**To:** Development Permit Panel

**File:** DP 19-881156

**Re:** **Application by Minoru View Homes Ltd. for a Development Permit at 5740, 5760, and 5800 Minoru Boulevard**

PLAN #6a - SOUTH ELEVATION

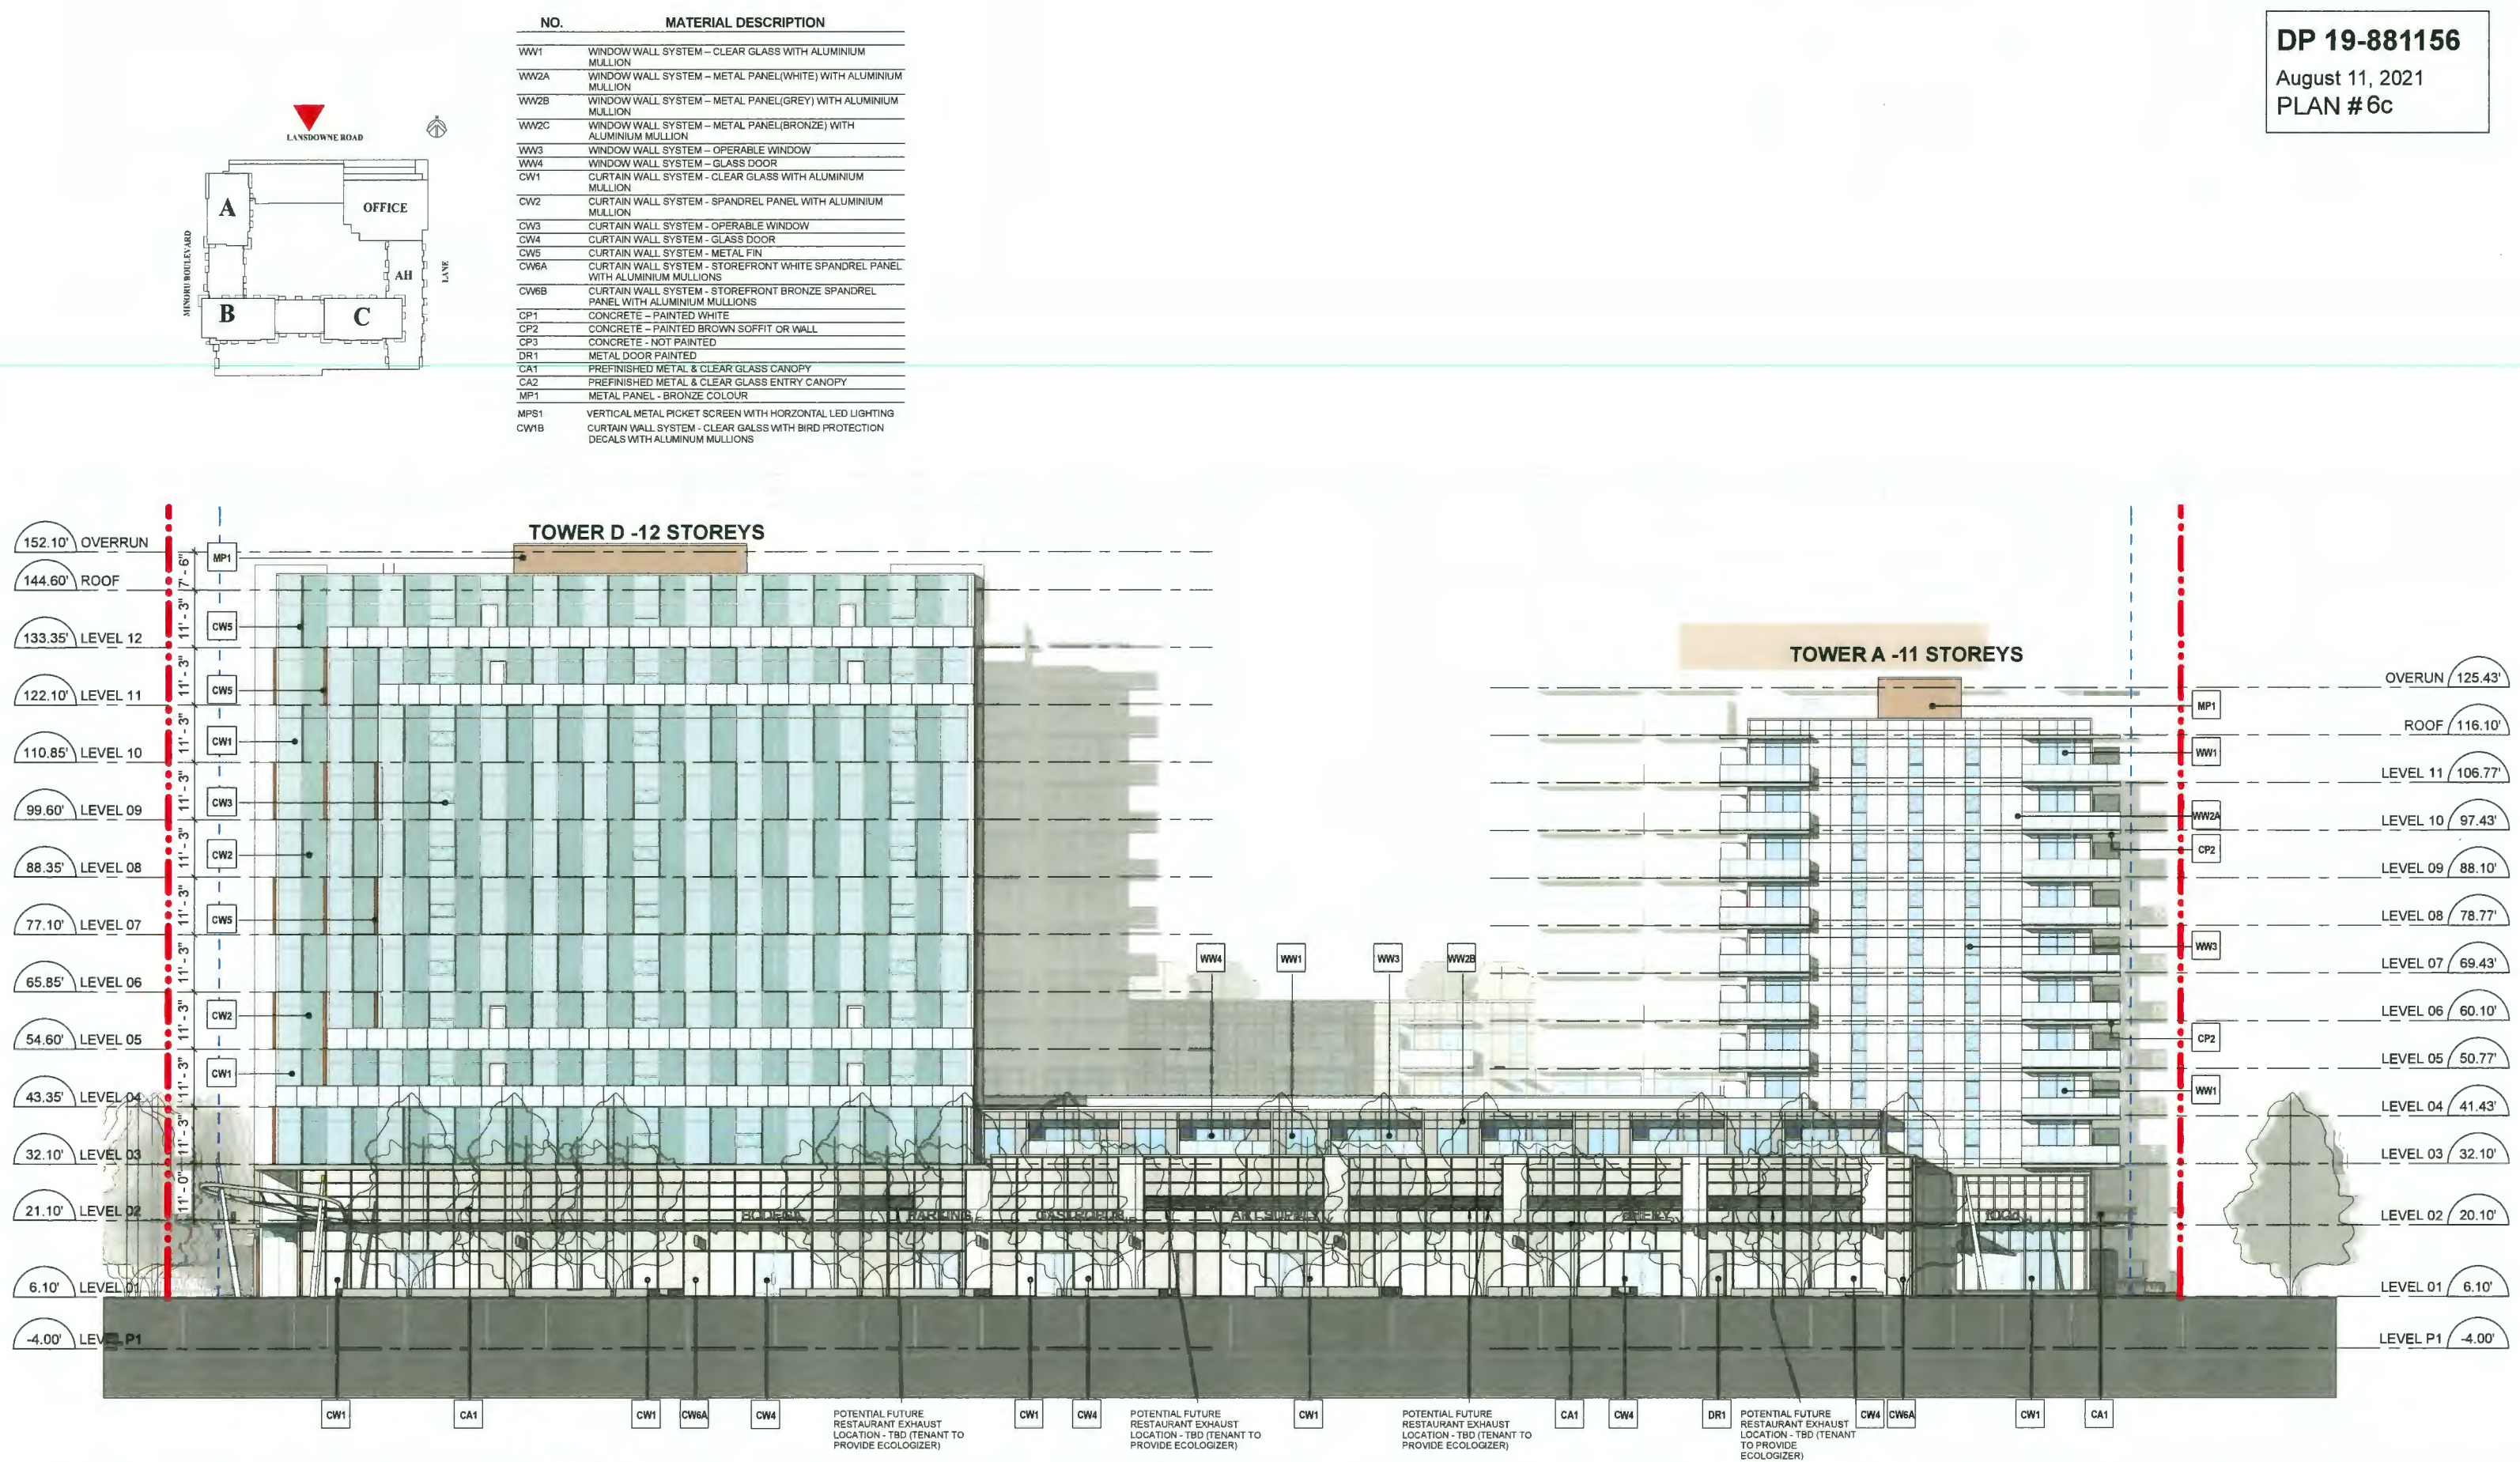
- review the accuracy of the labelling of exterior building materials on the south elevation drawing on page 79 of the proposal package; for example, the window wall with spandrel panel has been incorrectly labelled as "CW5" which is actually wood-look metal fin;
